Subject: Duke Energy Carolinas, LLC
Oconee Nuclear Station
Renewed Facility Operating Licenses Numbers DPR-38, DPR-47, and DPR-55;
Docket Numbers 50-269, 50-270, and 50-287
Responses to Request for Additional Information for the License Amendment
Request to Revise Portions of the Updated Final Safety Analysis Report Related to
the Tornado Licensing Basis; License Amendment Request: 2006-009

Duke Responses to RAI

DUKE POWER COMPANY
OCONEE NUCLEAR STATION UNIT 3
ONE LINE DIAGRAM
6900V & 4160V STA AUXILIARY SYS

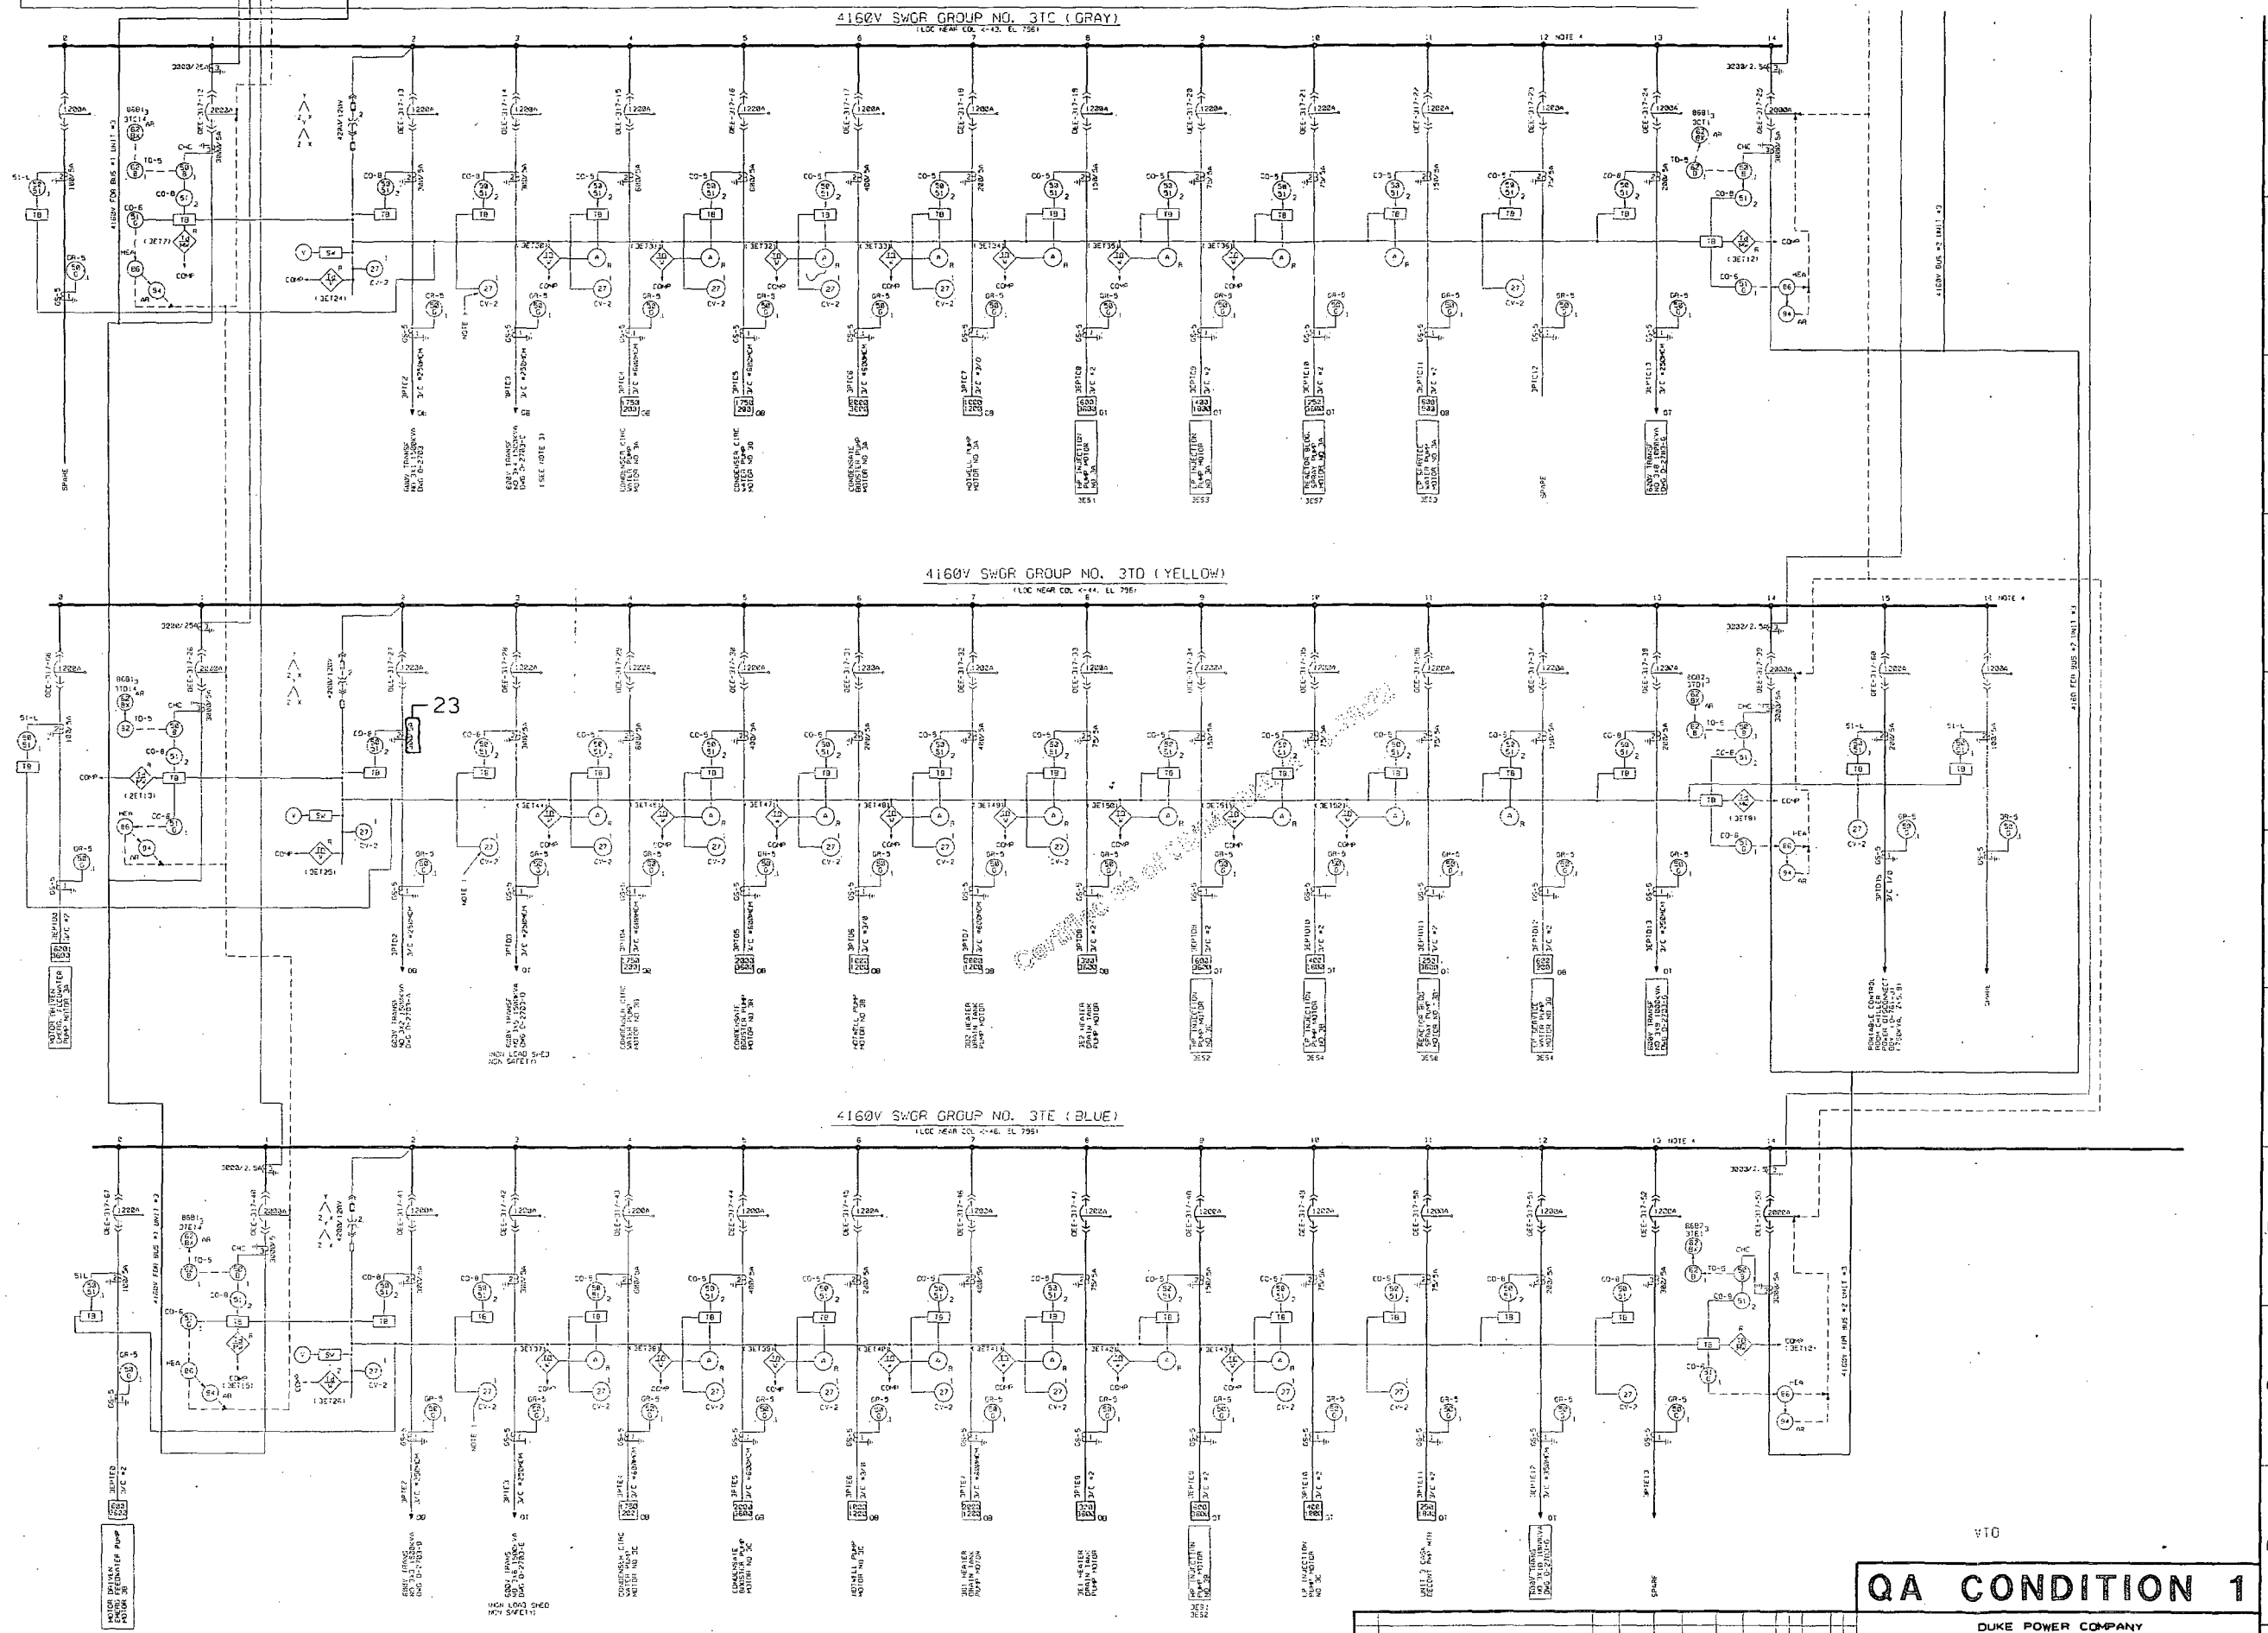
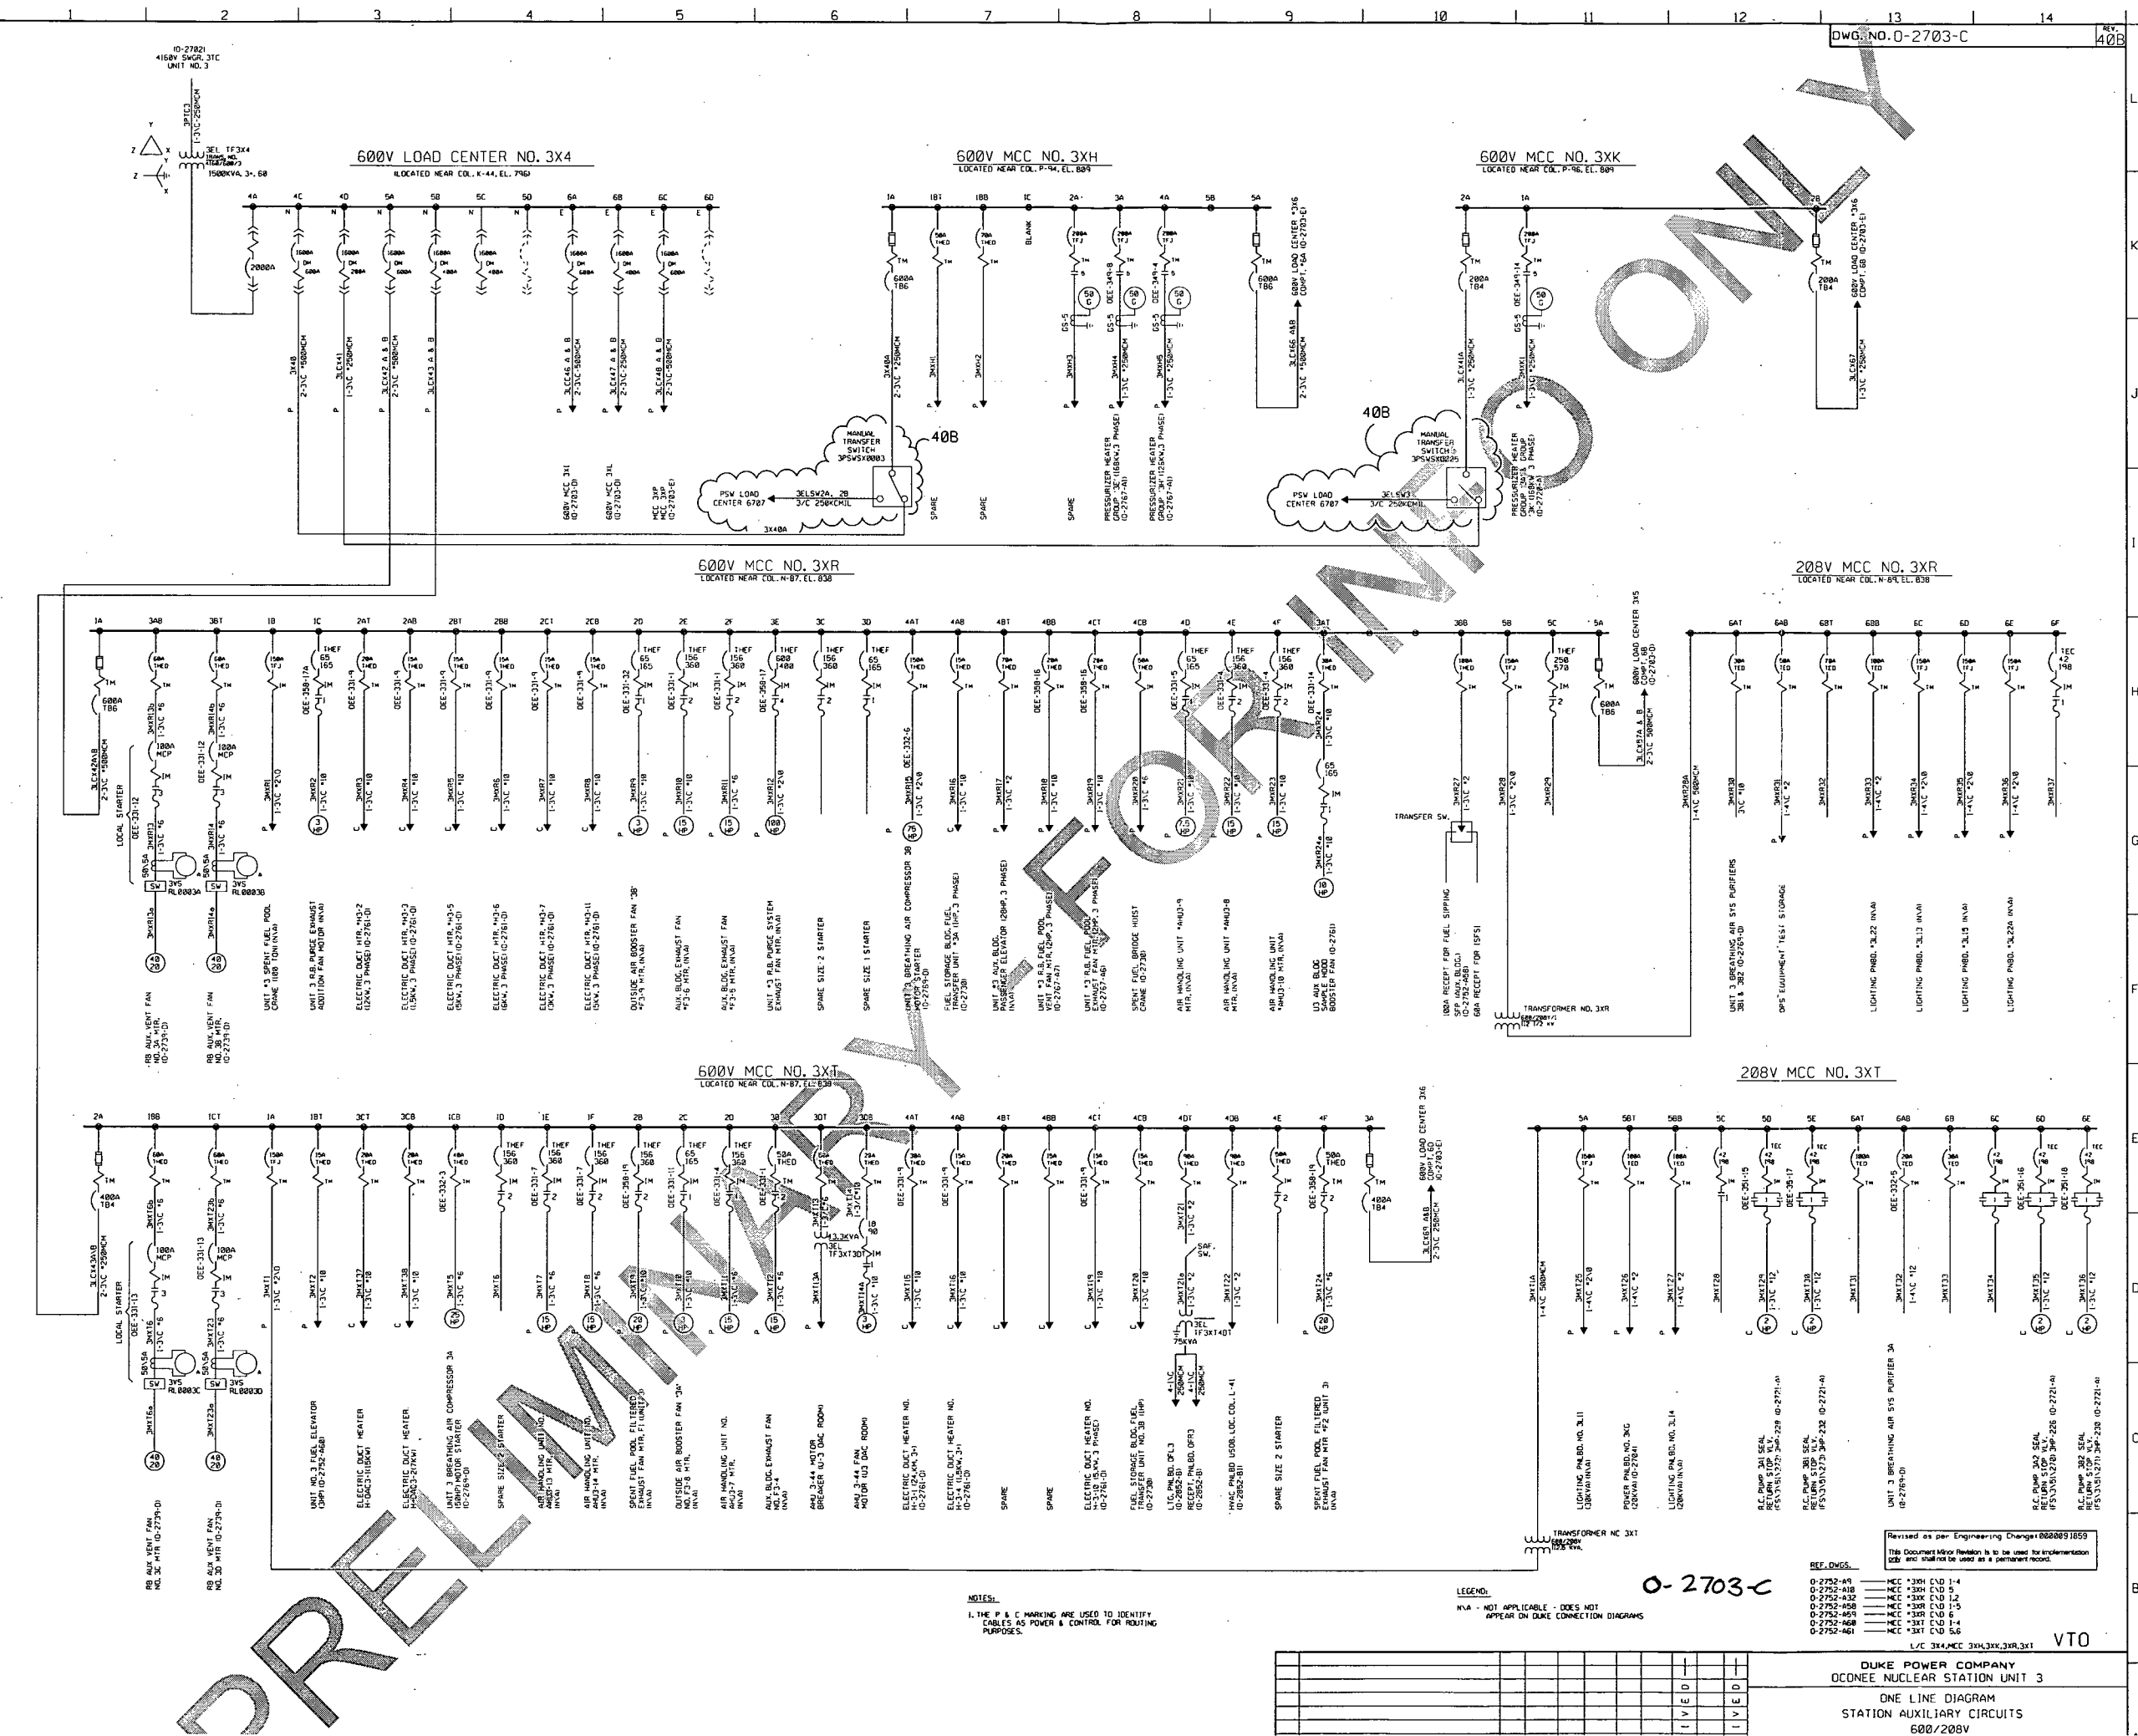
The licensee states in Enclosure 2, Figure 1 of the LAR, that two new power feeds will be installed to the auxiliary building (AB) with one power supply to the Unit 1, 2, and 3 AB equipment high pressure injection (HPI) pumps and vital I&C normal battery chargers and other power supply to the backup power to the Units 1, 2, and 3 pressurizer heaters. Provide the following information concerning this installation: 1) compare and contrast the existing power supply requirements for the above loads, 2) how the electrical separation, independence, and redundancy requirements are maintained, 3) summary of the voltage

analyses for the equipment/components affected by this modification, 4) design details for the new power feeds to AB, 5) periodic inspections and testing schedule for the these cables to monitor their performance, and 6) provide the electrical schematics and one-line drawings for these power feeds.

3. Analysis of the voltages for the equipment/components affected by this modification will be analyzed in an Electrical Transient Analysis Program (ETAP) calculation associated with PSW design packages, which are under development.
